Project Description: Idaho State University

**Project/File:** **Idaho State University / MER23-0070 / H-2024-0027**  
This is an annexation and rezone application for the future development of academic buildings, university housing, clinical space, multi-use facilities, and outdoor amenities on 23.25-acres.

**Staff Approval:** August 2, 2024

I-84/Meridian Road Intersection

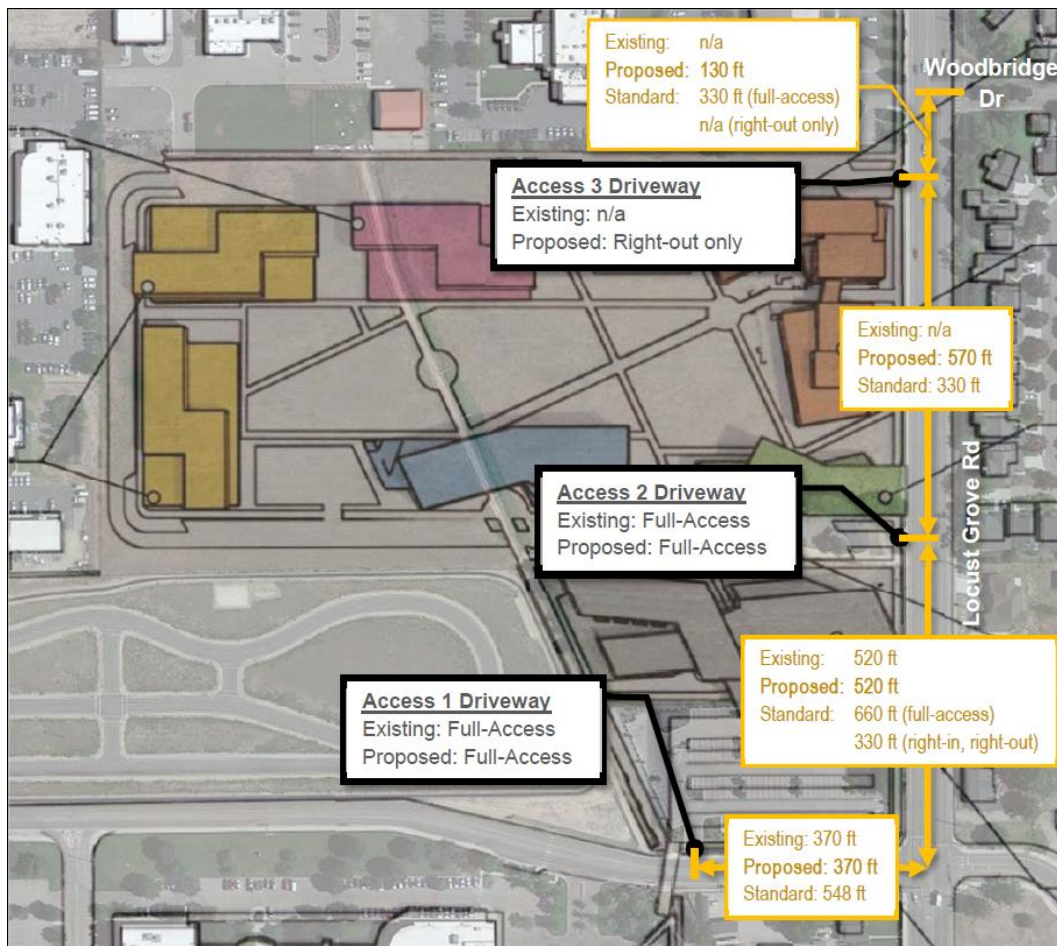
There is an existing capacity deficiency at the I-84 and Meridian Road intersection. Due to the capacity deficiency currently existing and the development only expecting to contribute 1% of the intersection traffic volume in 2035, detailed capacity analysis of mitigation options was not performed for this traffic impact study.
